UNITED STATES PATENT AND TRADEMARK OFFICE

10/757,131

Office Action Summary

DETAILED ACTION

REPLACEMENT SHEET

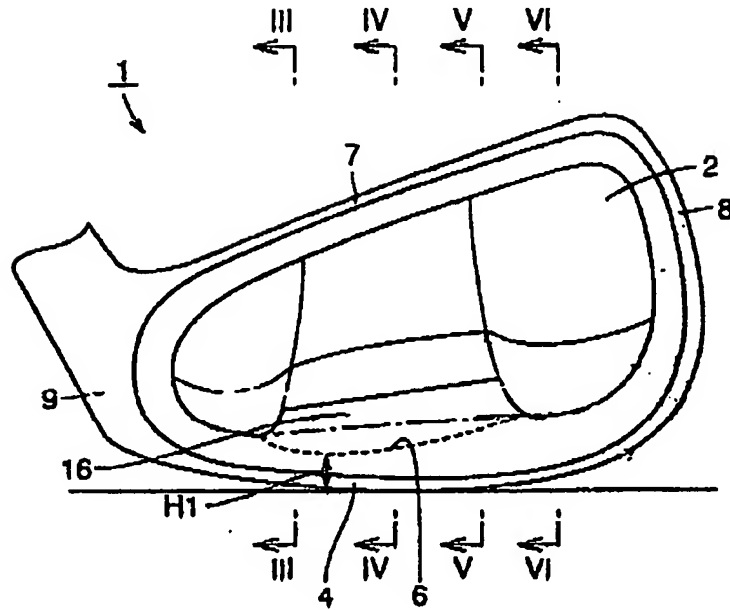
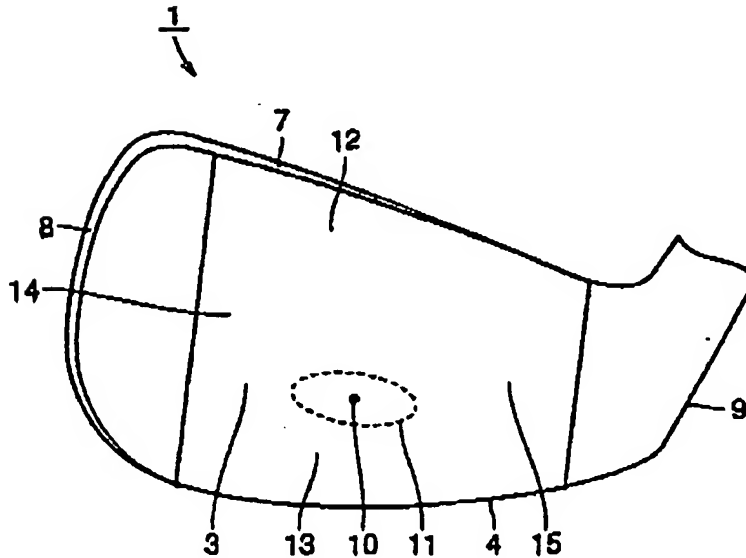
2. The changes to the drawings are agreed with and the objections under 37 CFR 1.84(p)(5) are removed.
